SUNDRY NOTICES AND REPORTS ON WELLS

Wilson #4

P&A Proposal
SJ8hms
3/3/94

Conditions of Approval

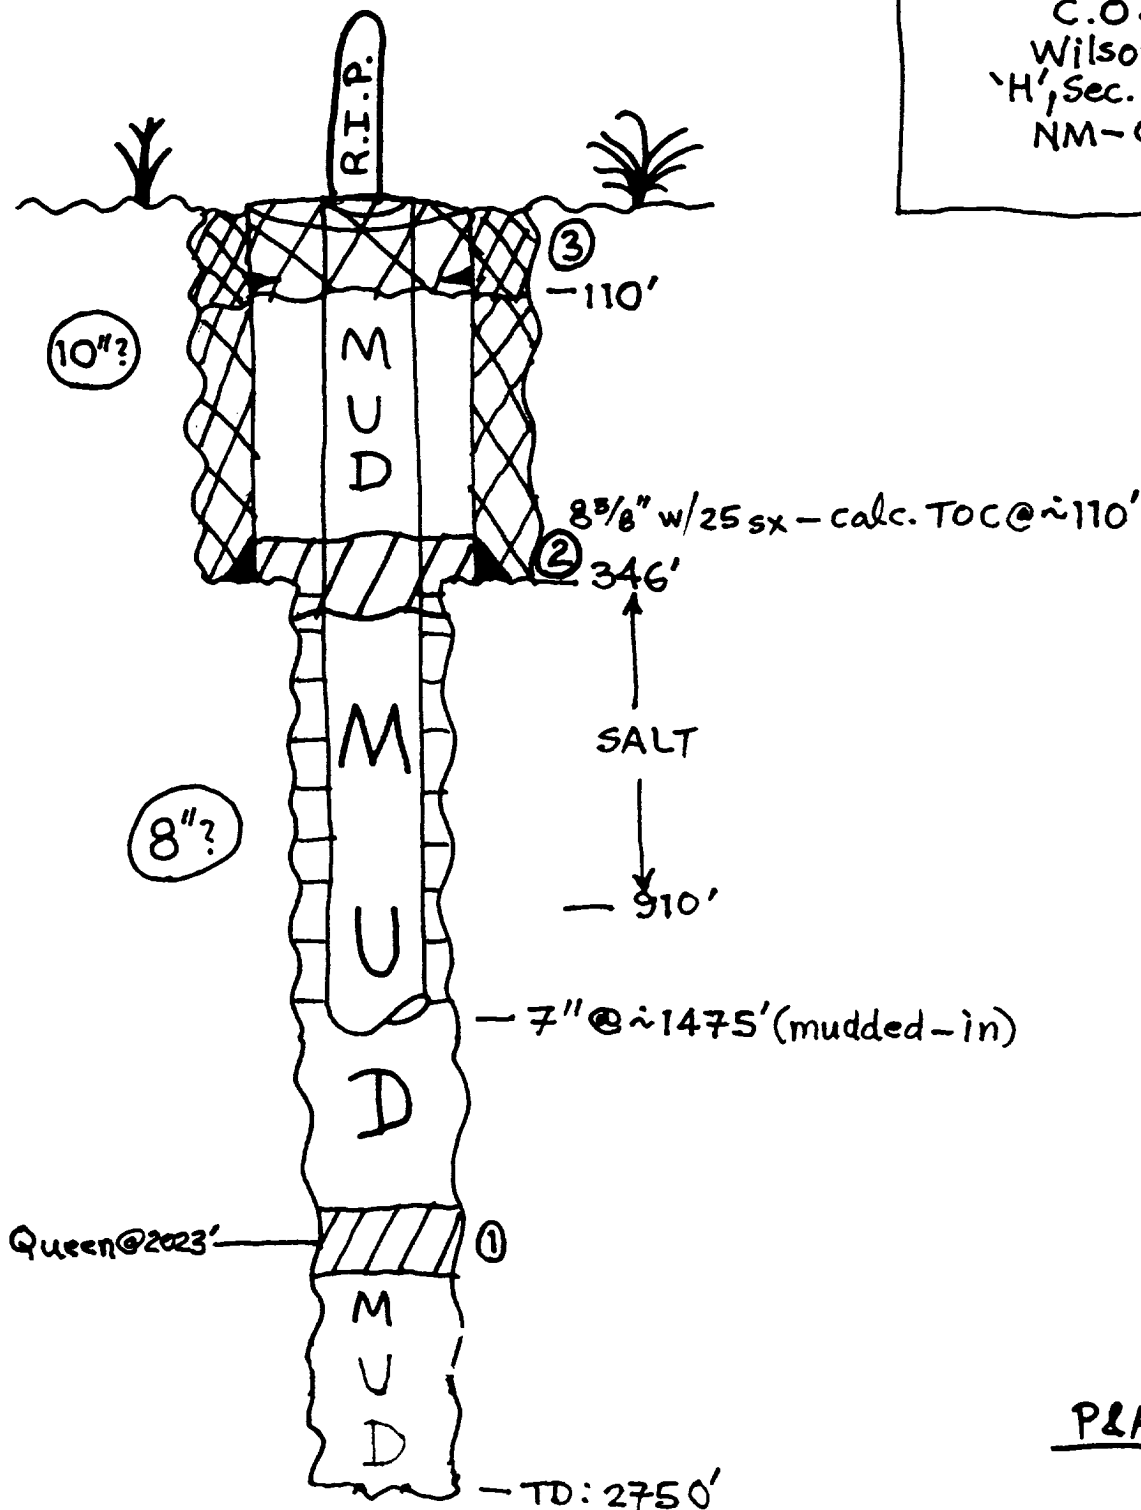
- ① After displacing bottom of hole w/ 9.0 ppg mud (minimum), spot 100' cmt. plug across top of Queen @ ~2025' & TAG PLUG.
- ② After pulling mudded-in 7" csg., spot 100' cmt. plug across 8⁵/₈" csg. shoe @ ~346' & TAG PLUG.
- ③ Perforate 8⁵/₈" csg. @ ~50'. Pump sufficient cmt. down 8⁵/₈" csg. such that cmt. is forced out of the perfs. and fills the 8⁵/₈" x Borehole annulus to surface.
